Office Action Summary

10/635,585

ZAIC, DAVID

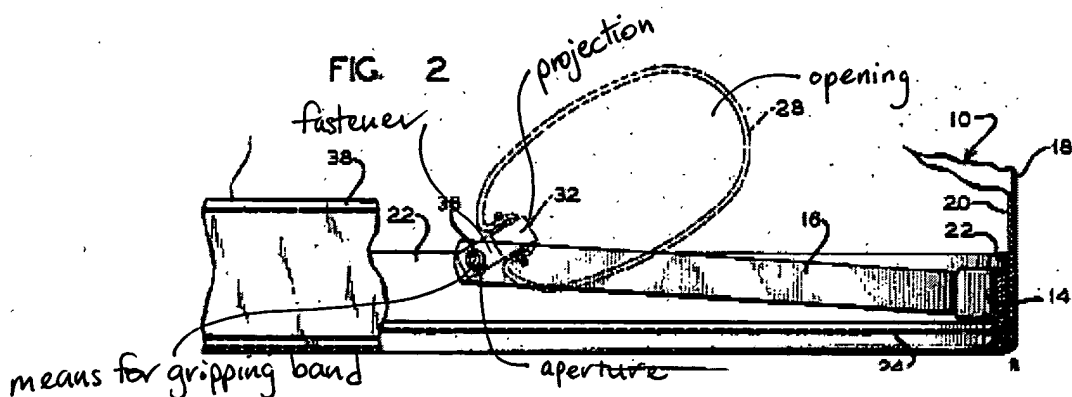
Mougel discloses an ear muff having a support with a fastener integral with a hoop 28. The fastener includes means for gripping band 16 wherein the means for gripping includes a perimeter defining an aperture. A projection extends into the aperture and the hoop 28 has a rail defining an opening. The hoop 28 is capable of being positioned in an expanded position and a compressed position since it is made from wire. A cover 12 is provided and sized to receive the hoop (see Figure below).
